PROPOSED MEADOW WALK DEVELOPMENT

LIGHTING PEER REVIEW

April 10, 2008

PRELIMINARY DRAFT SUBMISSION

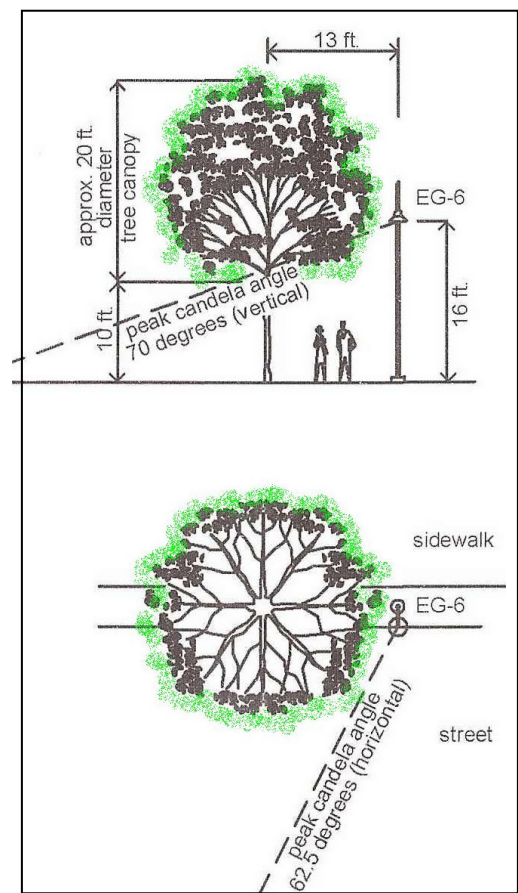
Lighting poles that are located along Main Street are generally positioned as to avoid sidewalk tree wells. Table X in the 40R Design Standards calls for trees to be located along Main Street, at the Village Green, and along Residential Streets at 50-feet on center. Lighting poles have been designed to be located at a varied spacing to provide the lighting illuminance criteria that is stipulated in the Design Standards. Accordingly, there are a number of locations on the lighting plans where lighting poles are indicated to be located immediately beside a street tree.

The lighting fixture/pole types that are indicated to be installed along Main Street are listed in the application as Type EG-6. These lighting fixtures are mounted at a height of 16-feet. The photometric distribution for these light fixtures is such that the peak intensity of light in candelas is emitted at a vertical angle of 70 degrees (based on 0 degrees being straight down) and at a horizontal angle of 62.5 degrees (based on 0-180 degrees being parallel to the street curb). To assure that the maximum intensity angle is not obscured by street tree foliage, the type EG-6 lighting poles should be installed no closer than 13-feet from the center of any street tree. The applicant should be required to coordinate all lighting pole locations with the final landscaping plan to assure that the light is not obscured by trees to demonstrate conformance to 40R Design Standards paragraph 5.F.2.c

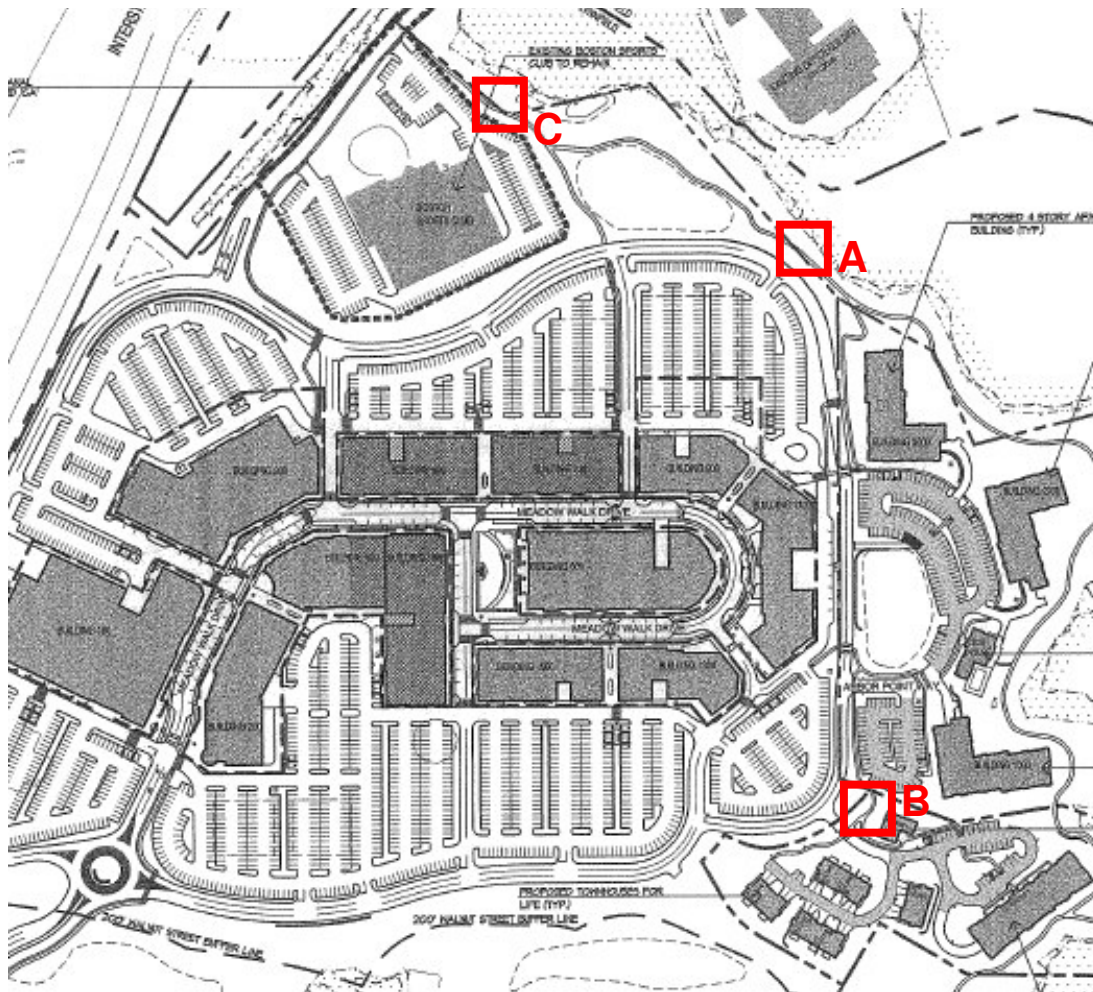
It should be noted that the section of roadway that leads into the garage at Building 3000 is relatively under lighted. The relative proximity of the property line makes this roadway difficult to light with pole lights without exceeding 0.2 footcandles at the property line. Main Street, the Perimeter Loop road and the Residential roadways all conform to 40R Design Standard paragraph 5.F.7.a.

REVIEWER'S COMMENT: It is likely that supplemental light could be provided for this section of road by means of wall mounted fixture(s) at the end of Building 3000.
